DATE: 06.24.2014
TO: ProTrak
FROM: Bill McDow
 Transportation Planning

■ **SOLD BY THE SEA REALTY [TRC Plan Review]**

☞ Initial Review Note ☞

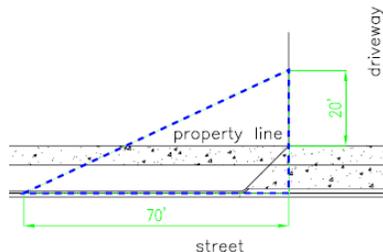
1. Increase the distance of the driveway curb return at intersecting property lines measured at the street corner. The driveway curb return must be at least 6.5' from intersecting property lines. [\[Chapter VII, C, Table 4 CofWTSSM\]](#)

2. Show driveways for adjacent lots and lots across the street.

3. Driveways shall be City-standard ramp-type driveways. Show appropriate City standard detail(s) on plan. [[Chapter VII ,Detail SD 8-02 \(curb\) CofWTSSM](#)]

4. Dimension driveway widths and tapers. [[Sec.18-529 CofW LDC](#)]
5. The minimum two-lane driveway width is 23'. [[7-9 CofW Tech Stds](#)]
6. Driveways are to intersect the street at a 90 degree angle. [[7-11 #3 CofW Tech Stds](#)]
